Name of Subdivision: Briar Chapel – Phase 5 North

RE: Briar Chapel – Phase 5 North
Conditional Use Permit Stipulations

From: John Strowd [pyro@nc.rr.com]
Sent: Tuesday, October 05, 2010 2:32 PM
To: Curtis M Blazier
Cc: Lynn Richardson; Thomas Bender; Mark Riggsbee
Subject: Re: Briar Chapel Phase 5 North - revised fire truck access Lots 507-514

From: Melissa Guilbeau
To: Lynn Richardson;
cc: Jason Sullivan; Curtis M Blazier; glivengood@mckimcreed.com;
Lee Bowman;
Subject: Briar Chapel Phase 5 North final comments
Date: Monday, October 04, 2010 10:58:28 AM
Attachments: Handicap Ramp Exhibit.pdf

McKIM & CREED
 BRIAR CHAPEL - PHASE 5 NORTH
 OCTOBER 4, 2010
 40' 0 40' 80'
 SCALE 1" = 40' (Horiz.)

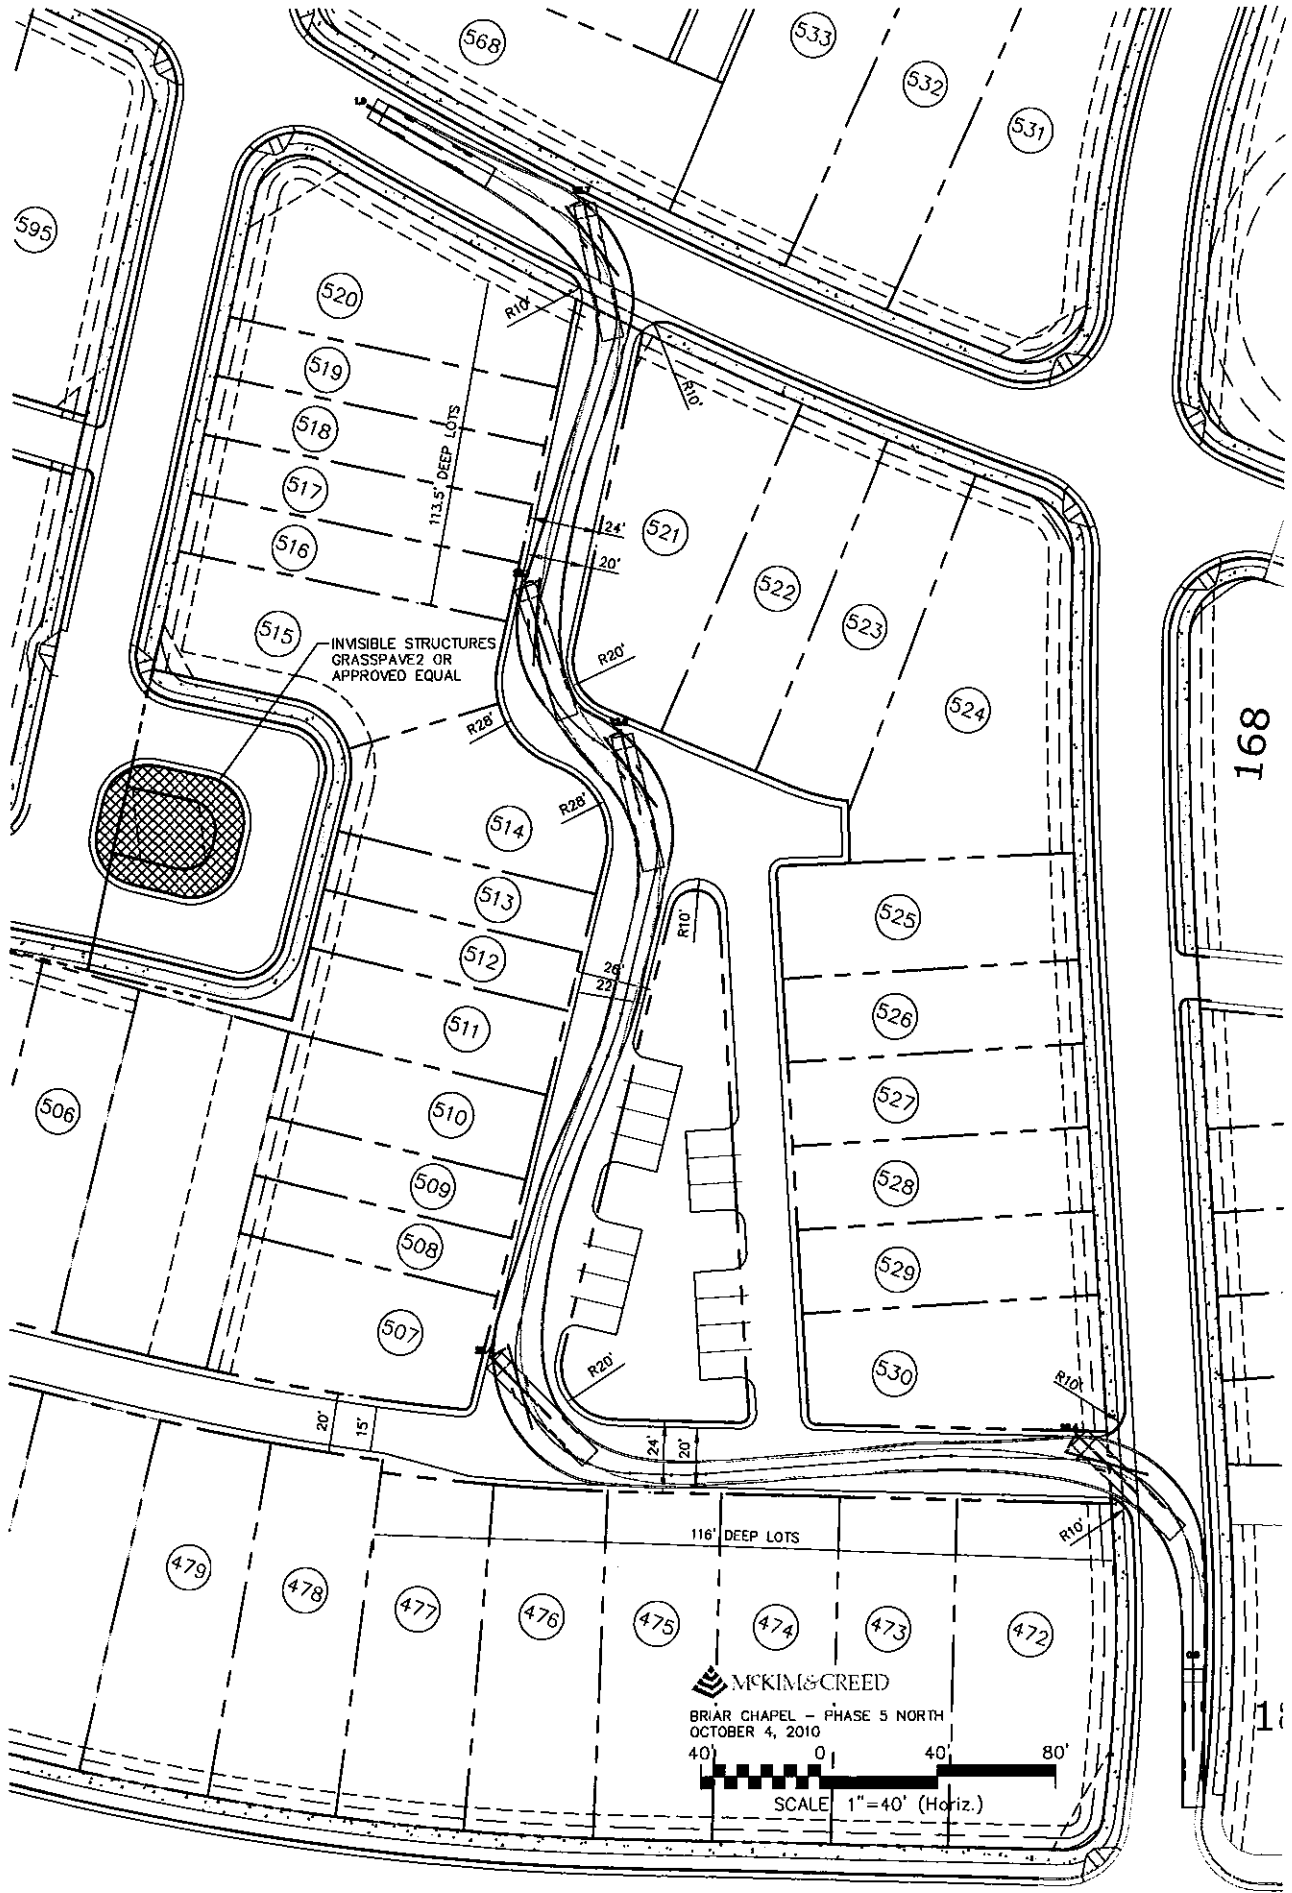
Item 1: You mentioned that it was prohibited on-street parking in the alleys. I rode through parts of Briar Chapel on Monday, 10-4-2010 and Tuesday morning 10-5-2010, there appeared to be a considerable amount of parking in alleys and on the street in front of residence's. Accessibility to some structures in the best conditions, may be difficult. Is there someone that is monitoring and enforcing parking?

Item 2: You mention the aerial truck should be able to sufficiently make the turns through the proposed alleys without damaging structures. The word "should" leaves a lot to be desired. Personnel drove a 36 ft. fire apparatus through a portion of Briar Chapel today, and expressed concern with turning and maneuvering apparatus.

Item 3: You mention the grassed porous pavement which is designed to handle the load of a fire truck. Our current aerial has a gross gvwr of 75,000 pounds and currently weighs about 66,000 pounds. Will this grassed area support this amount of weigh? For lots 507 to 510, are still accessed by an alley way. I appreciate the work you have provided for increase in width from 15 ft. to 22 ft. and changing angle of turns. However, aerial operations may still be limited with this accessibility.

I appreciate you sending a picture of aerial apparatus that you are using and the description of the apparatus traveling through the alley. I still have concerns with the current drawing, even more so now. Our current aerial is 46 ft long and is considered a 95 ft. aerial platform apparatus, not a stick ladder, which is similar to what your drawing reflects. Our personnel not only have to be concerned with turning radius, but with over hang of the platform, also. I realize that you are showing concessions in your drawings, but we are trying to access structures from an alley, with know road access from the front. I offer you the opportunity to look at our aerial at North Chatham Station 2. Also, for consideration if a second or third platform is needed for a fire, Chapel Hill FD or Carrboro FD would be notified. Currently, there apparatus are 100 aerial platforms. Thanks so much for your continued work on this issue.

I have reviewed the "revised" plan concerning emergency apparatus access to lots #507 thru #514. The plan was also forwarded to Chief John Strowd, North Chatham Fire Department, for his review and comments which I had previously forwarded to you. It "appears" that the intent of the NC Fire Prevention Code has been met in regards to fire apparatus road access widths, however I do share Chief Strowd's concern in regards to the maneuvering of large apparatus as depicted on the plan. The NC Fire Prevention Code (Section 503.2.4) states that "the required turning radius of a fire apparatus access road shall be determined by the fire code official". Whereas the Chatham County Fire Marshal's Office does not have such apparatus and that the different types of apparatus have varied turning capabilities I work closely with the fire departments to determine what is actually required. It would be my "recommendation" that Chief Strowd's concerns be further reviewed and discussed to ensure that safe access is provided for both apparatus and personnel. If I can be of further assistance to you in this matter, please contact me. **Thank-You.**

1) Parking - the Briar Chapel covenants prohibit on-street parking in the alleys. In the event of a fire, if a car is parked in the alley, it will be doing so illegally.

2) Obstructions and Platform Overhang-- there are no trees or light poles in the alley right-of-ways, so even with the aerial bucket hanging over 4-5 ft beyond the front bumper, the aerial truck should be able to sufficiently make the turns through the proposed alleys without damaging existing structures. The overhang of the platform does not affect turning radius. The wheel base and overall bumper to bumper truck dimensions are correctly reflected in the schematic diagram and these are the main components in the turning analysis.

3) Access – Lots 511-514 do have road access from the front. We have proposed making the common area square to the west of these lots a grassed porous pavement which is designed to handle the load of a fire truck. Lots 507-510 will have access from the alley. The alley will be pavement without curb and gutter.

John,
Per our phone conversation yesterday, we have revised the bulletin drawing showing fire truck access to Lots 507-514. We have increased the radii at Lots 514 and 521 to 20 ft and the radii Lots 520 and 521 to 10 ft, widened the alley to 22 ft with 26 ft ROW, and increased the radius at the top of the triangular area to 10 ft. We believe that these

measures should help to provide safe access for personnel and apparatus in case of a fire in the homes located on Lots 507-514. At the same time, we need to consider our overall impervious surface area (ISA) for the development and that every time we widen alleys from their typical 15 ft width, we increase our ISA percentage, so we are trying to be mindful of that as well.

MCKIM & CREED <small>1730 Varsity Drive, Suite 500 Phone: (919)233-8091, Fax: (919)233-8031 C-0342</small>	BRIAR CHAPEL PHASE 5 NORTH - HANDICAP RAMP PLAN	
	NNP BRIAR CHAPEL, LLC	B-1

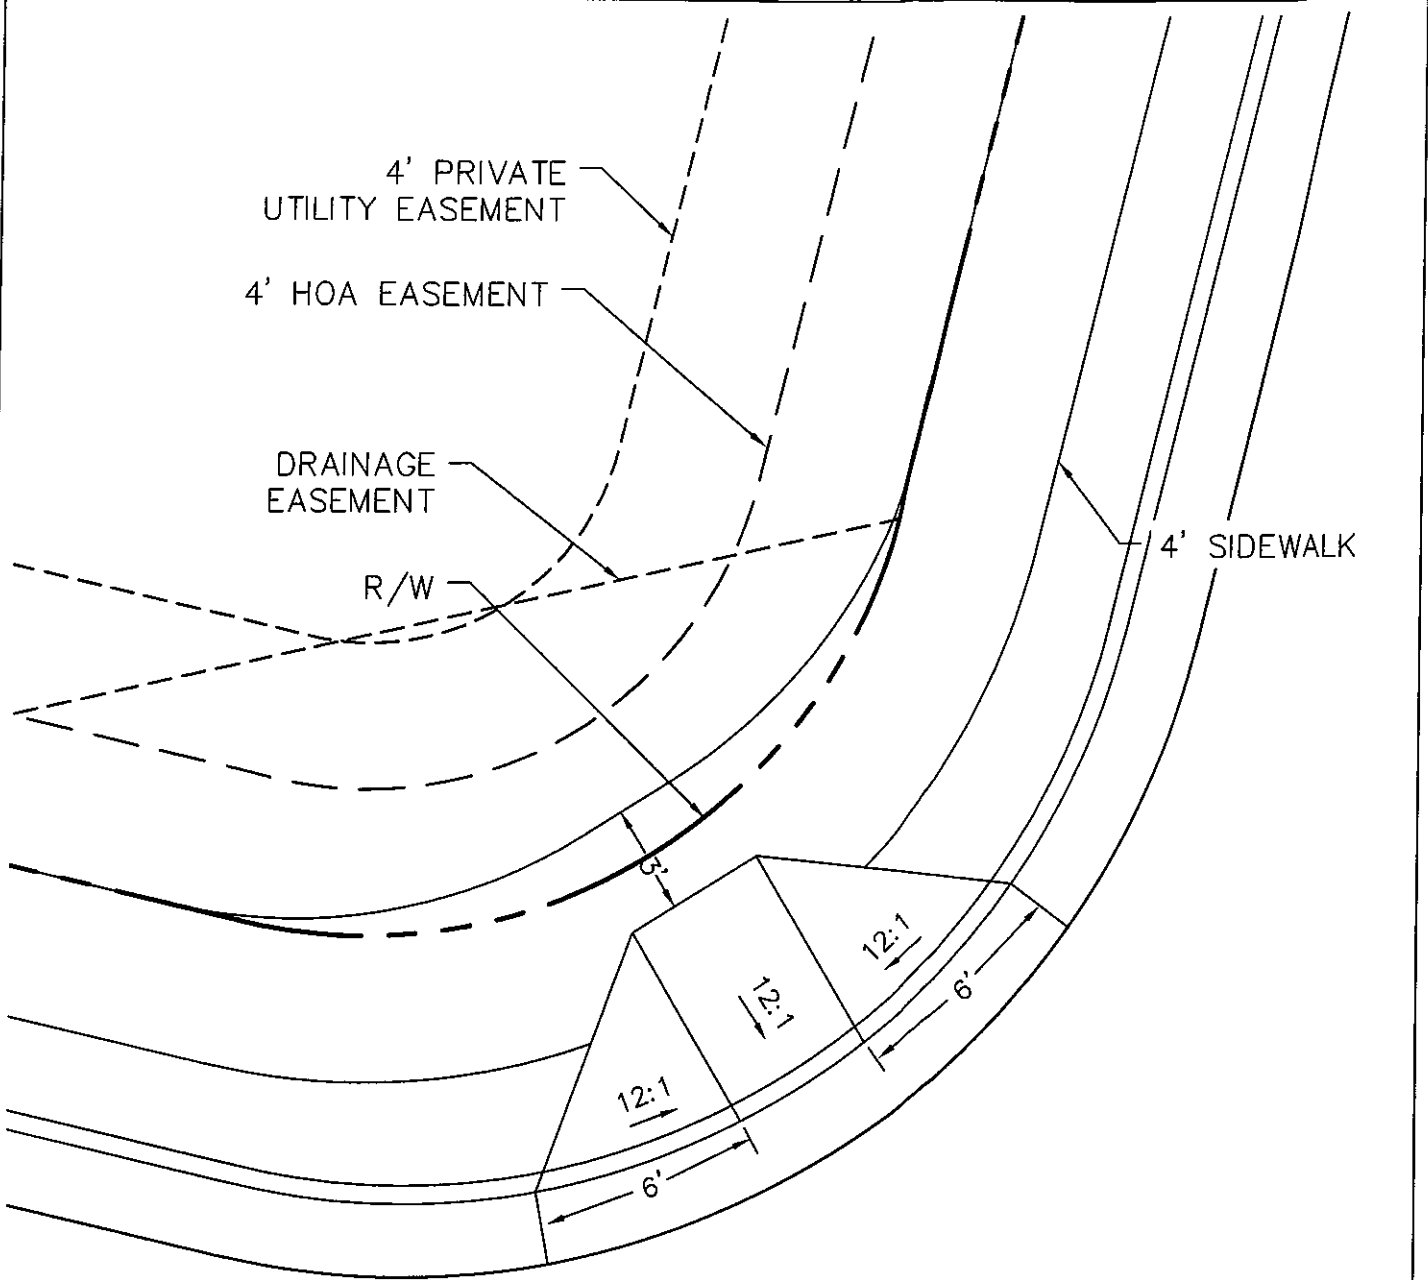
- 3. There should be at least a 4 foot wide level area (<2% cross slope) at the top of each wheelchair ramp. Briar Chapel has agreed to provide a 3 foot wide level area at the top of each wheelchair ramp, as shown in the attached exhibit, provided that this feature is approved by NCDOT as part of the approval of any roadway plans. My initial recommendation of a 4 foot wide level area was based on best practices from AASHTO's "Guide for the Planning, Design and Operation of Pedestrian Facilities." In further research, I have found that the US DOT's minimum ADA standards for transportation facilities call for at least a 3 foot wide level area. Therefore, Briar Chapel's proposed 3 foot wide level area at the top of each wheelchair ramp is an acceptable resolution.*

3. *There should be at least a 4 foot wide level area (<2% cross slope) at the top of each wheelchair ramp.* Our understanding from you is that this standard finds its origin in guidelines established under the Americans with Disabilities Act ("ADA"). Our counsel advises that the sidewalk construction standards of the ADA are not obligatory in this setting. And, of course, to our knowledge there are no provisions in our Subdivision ordinance nor our CUP that impose the ADA standards. Nevertheless, we see pedestrian accessibility as very important and we want to make reasonable and appropriate accommodations when feasible and productive. We have consulted with our engineers and have agreed that we will voluntarily install a three foot wide landing area at the top of each wheelchair ramp in the Phase 5 North sidewalks. Apparently there are differences between the federal ADA sidewalk guidelines and the NC DOT guidelines for ADA compliance. This 3 foot level area should comply with the NC DOT guidelines. Of course, if this voluntary concession becomes a condition of the preliminary plat, compliance with the condition has to be contingent on NCDOT approval of the plans. In other words, we are willing to make this voluntary improvement but only if it meets with DOT approval. Attached is a bulletin drawing of the details on this landing area at the top of handicap ramps (see Section 406.4 of the federal ADA-ABA accessibility guidelines for additional info).

While slightly different from your proposal regarding the level area behind the handicap ramp, my understanding from conversations with you would be that you are satisfied with this resolution since it would be compliant with ADA standards.

MCKIN & CREED
BRIAR CHAPEL - PHASE 5 NORTH
OCTOBER 15, 2010

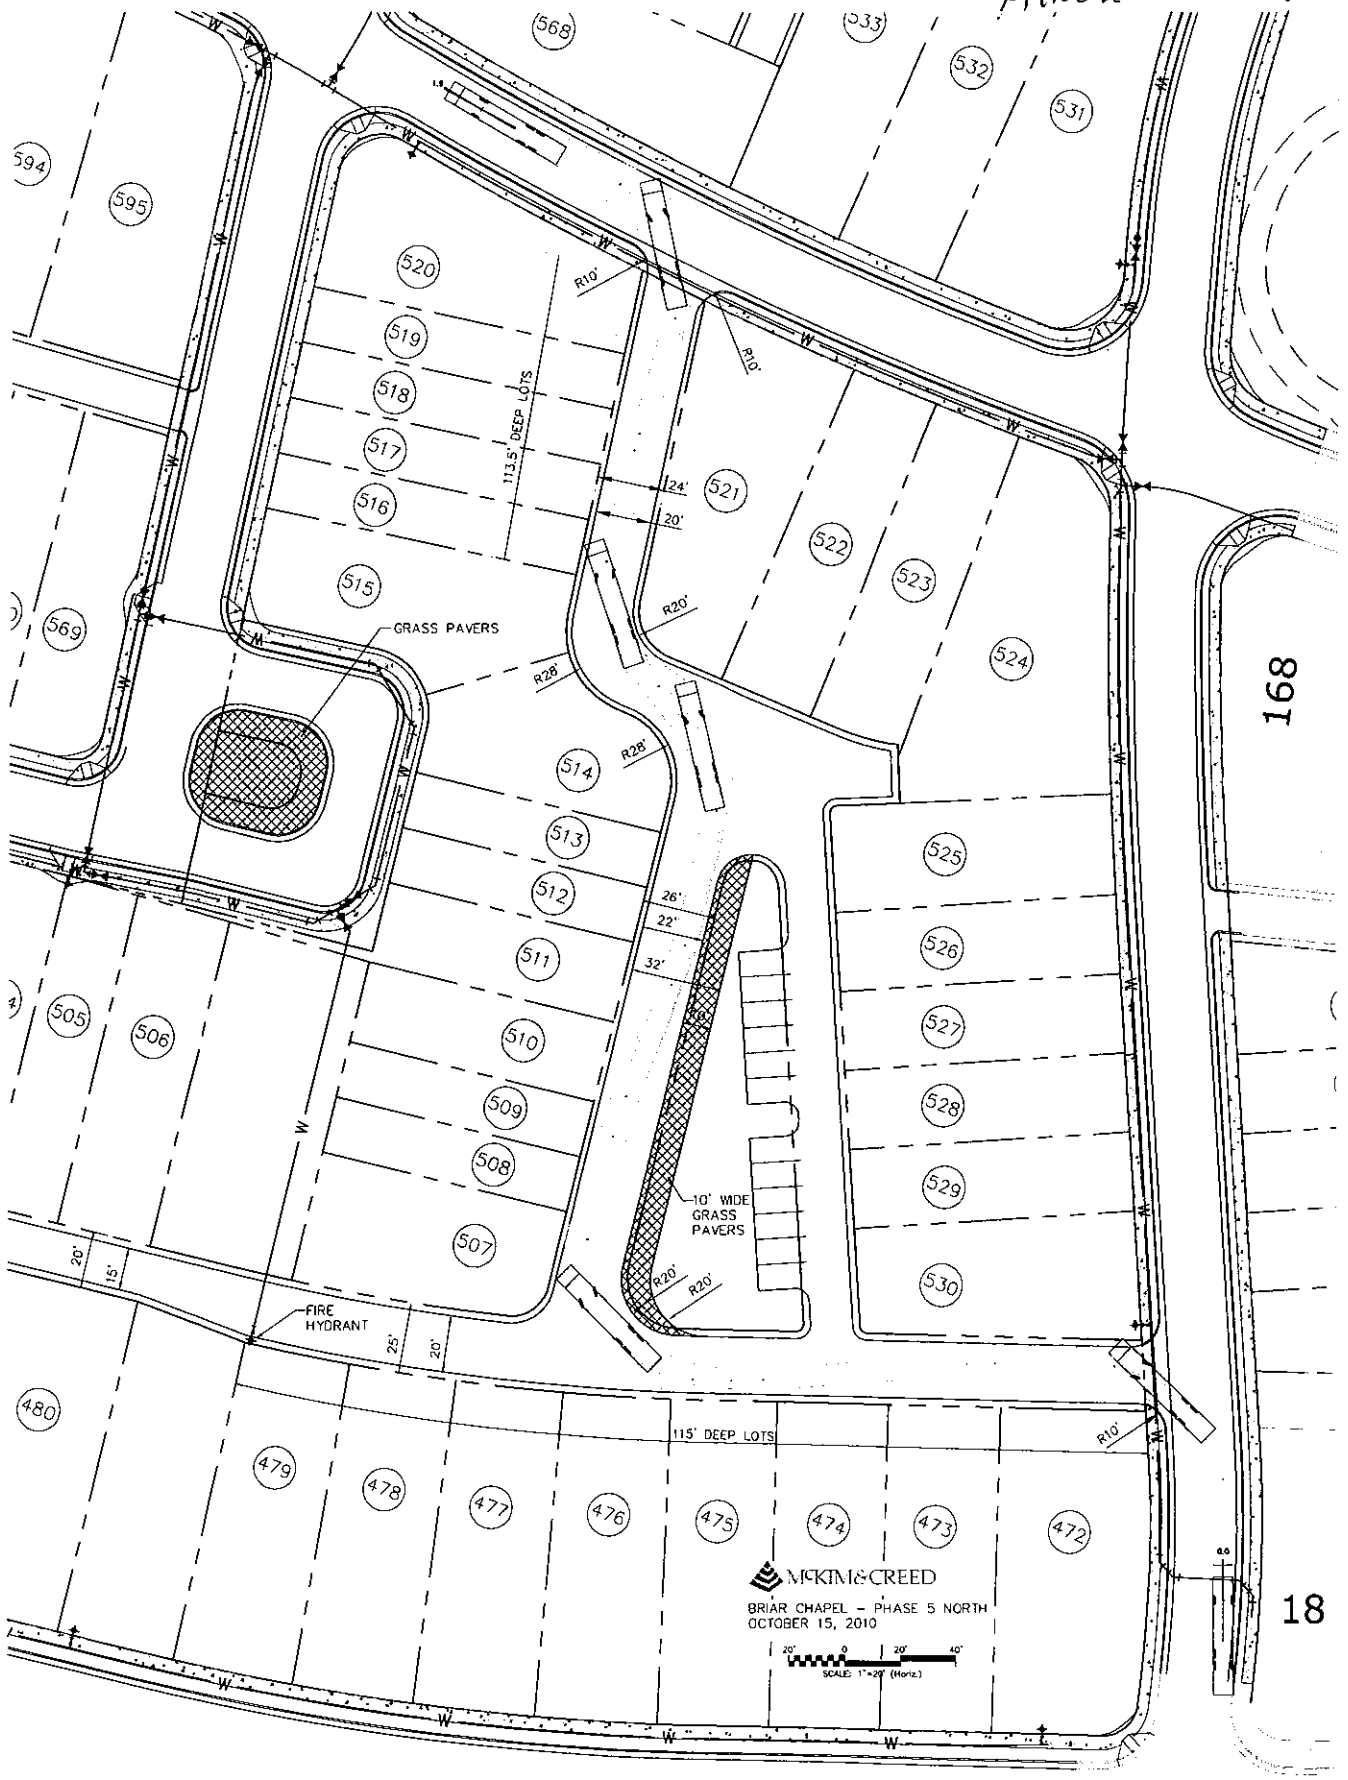
I want to thank you for all of your assistance in this matter and listening to my concerns, especially safety issues for personnel and access for apparatus. There are other subdivisions in our district that have alleys that give access to rear of structures, but presently these structures face a main road. Which appear to have adequate width for vehicles to access. My personal feeling, which goes back to safety of personnel and accessibility, they should be known structures that are accessed from an alley. I'm not sure if there are any additional phases in Briar Chapel that will present these same problems or not. As far as I am concerned, future structures that are accessed from an alley without facing a main road without adequate width and clearances are not acceptable and this issue should be looked at more in depth by Chatham County.

After several weeks of reviewing proposals, emails and meeting with personnel from Briar Chapel, input from staff at North Chatham and several conversations with you about my concerns, alley access to lots 507 to 511 and turning radius through lots 512 to 520 are a lot better than what was initially proposed. I still have reservations as mentioned above, but Briar Chapel did make concessions as far as additional fire hydrant at lot 479, move a hydrant to be placed at lot 530, change some turning radius, provide grass pavers to support apparatus, moved parking spaces, and agreed to mark asphalt with "no parking fire lane the length of the grass pavers. These changes would be acceptable for this portion as indicated on the map. This does not give the approval by the Fire Department, if any future lots express the same access concerns.
